Former ASARCO East Helena Facility Interim Measures Work Plan—2014

Prepared for
The Montana Environmental Trust Group, LLC
Trustee of the Montana Environmental Custodial Trust

May 2014

FIGURE 1-1
Interim Measures Components
Proposed for Implementation in 2014
Interim Measures Work Plan—2014
East Helena, Montana

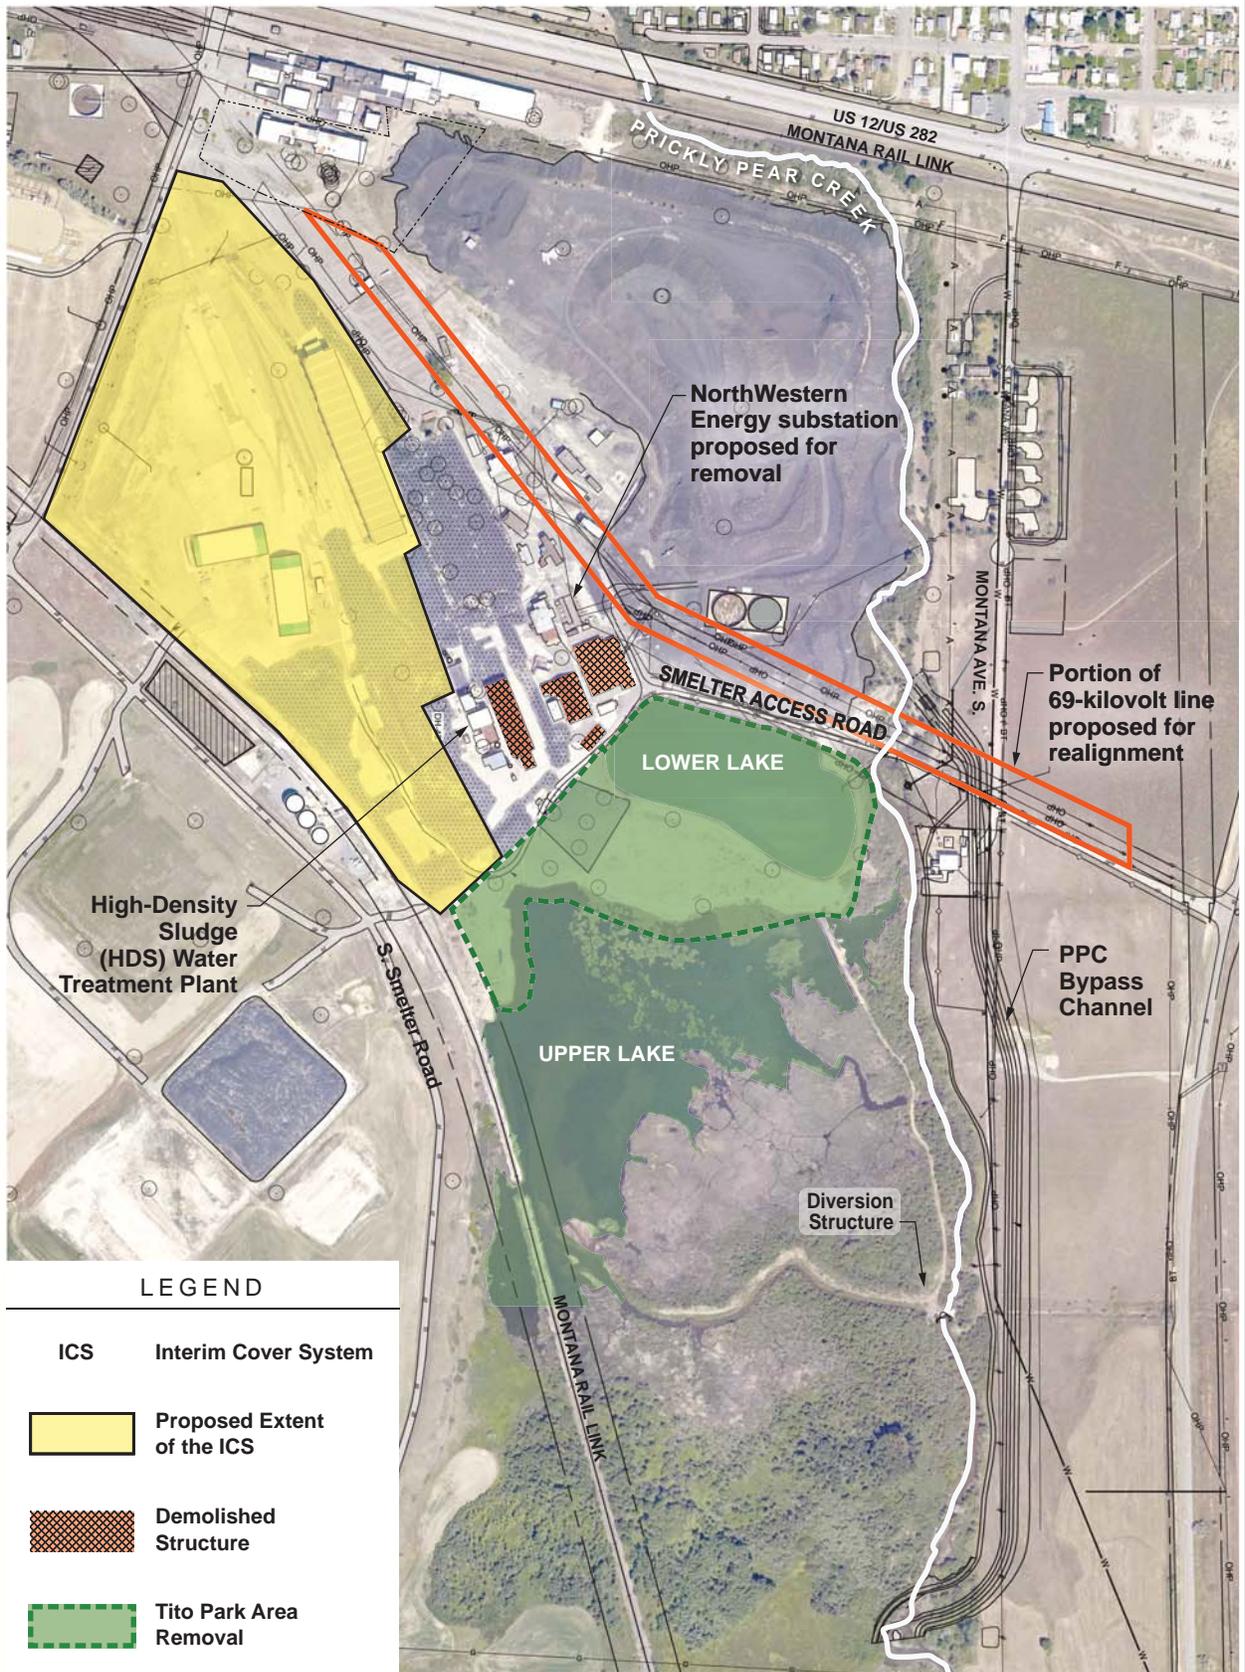
- 13) Figure 1 -1: Section 2.1.3 states that a materials balance analysis will be completed to estimate the volumes of soil to be excavated during the TPA excavation and the PPC Realignment construction and estimate the volume of material needed to construct the ET Cover System. It does not seem appropriate to decide the size of the ET Cover System based on removal volume estimates. Also, according to the IMWP, the ICS 1 consists of both excavated contaminated soil, plus a layer of clean fill over the contaminated soil. In the IMWP, please explain how the ET cover area is to be determined, and how can projected cost be estimated.

EPA Response – The rail corridors are located within the footprint of the first phase of the ICS, as shown in Figures 1-1 and 2-2 of the 2014 IMWP. The ICS and the final ET Cover will effectively control the infiltration of precipitation through these soils.

2. Existing information and data regarding site conditions, as summarized in the draft Phase II RFI indicate that consolidation of materials from the TPA onto the areas shown in IM Work Plan 2014 (Figure 1-1) will be protective without a liner. Consolidated materials will be isolated above the existing and post-South Plant Hydraulic Control IM (SPHC) groundwater table and below the ET Cover, such that the potential for exposure and for contaminant mass loading to groundwater will be effectively controlled without the need for a bottom liner system.

FIGURE 3-2
Arsenic Contamination,
Ground Surface to Depth of 8 Feet
Interim Measures Work Plan—2014
 East Helena, Montana

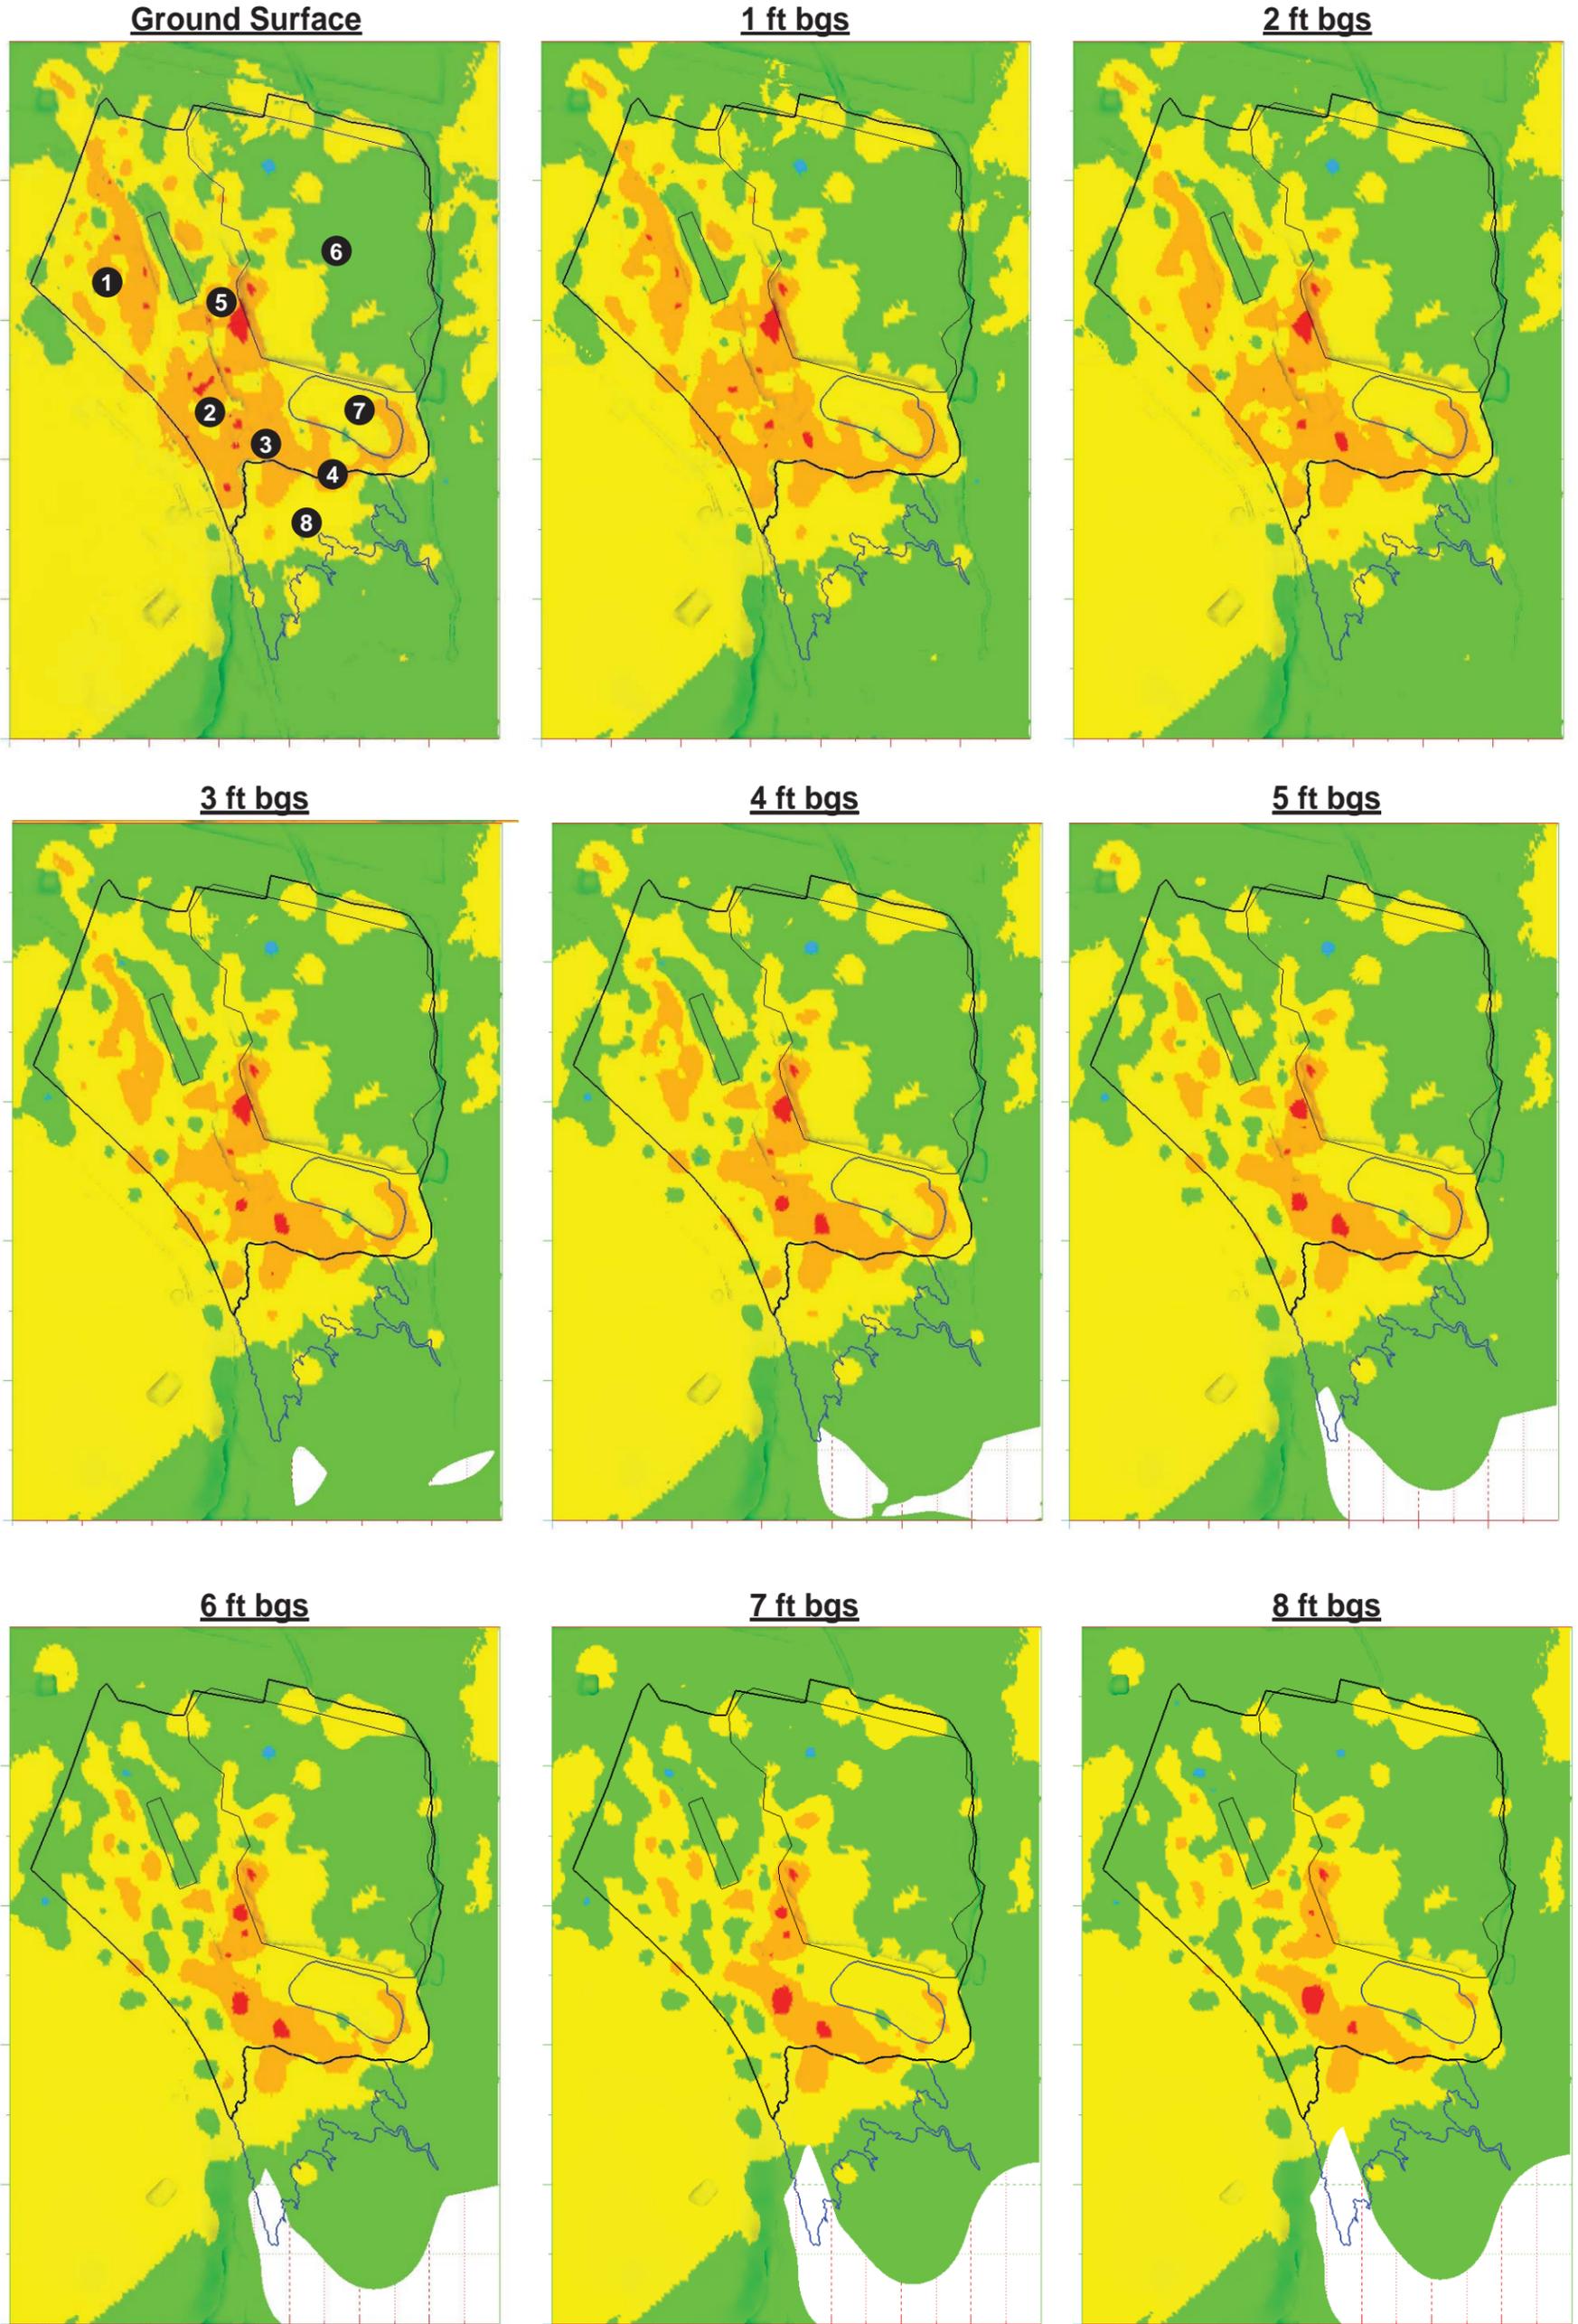
- 24) Figure 3-2: This figure makes it difficult to judge the actual extent and variation of soil contamination for arsenic. Actual soil data should be provided in tables as an appendix so the reader has some understanding of the concentrations of arsenic in various areas and at depth. Also, in the IMWP, please explain why no removal of soils in the Speiss Dross area are being considered, even though these soils have the highest concentrations of arsenic in soils on the site. Please provide the supporting data and analyses supporting the decision.

- 25) Figure 3-2 and Figure 3-3: Please explain why these figures only display the depth of contamination to 8 feet. The text or figures need to explain why this depth was chosen.

Section 3.1.1, p. 3-2, 4th paragraph. The presentation of soil concentration data in Figures 3-2 and 3-3 only reflect concentrations in the upper eight feet of the soil profile, while the data in Appendix A show high concentrations at greater depths. A more comprehensive statement indicating the thickness of the unsaturated zone (water table depth), and soil concentrations both above and below the water table would be useful to understand conditions.

EPA Response – Figures 3-2 and 3-3 were generated as part of the soil removal evaluation done to determine whether there were areas of the site where near-surface soils could be “scraped” into a smaller area in order to reduce the size and cost of an ET Cover. Therefore the MVS model generated graphical depictions of the upper 8 feet of soil to identify whether there were areas of where contaminants were present in only shallower soils. This explanation will be added to the IMWP to explain the basis for the figures.

EPA Response – Figures 3-2 and 3-3 illustrate soil data from the ground surface to a depth of eight feet to provide details on arsenic and selenium concentration data in surface and near-surface soil. The thickness of the unsaturated zone (or typical depths to groundwater) ranges from 30 to 40 feet. Soil data across both the unsaturated and saturated zones, from the ground surface to the top of the Tertiary ash/clay layer, are provided in Figures 3-4 and 3-5, along select cross-sectional lines through the former Smelter site. In areas of the main plant where contaminants were associated with materials handling and storage activities, contaminant concentrations tend to be higher near the ground surface and decrease with depth. Higher concentrations of contamination are found in deeper soil in areas associated with the former process water system.
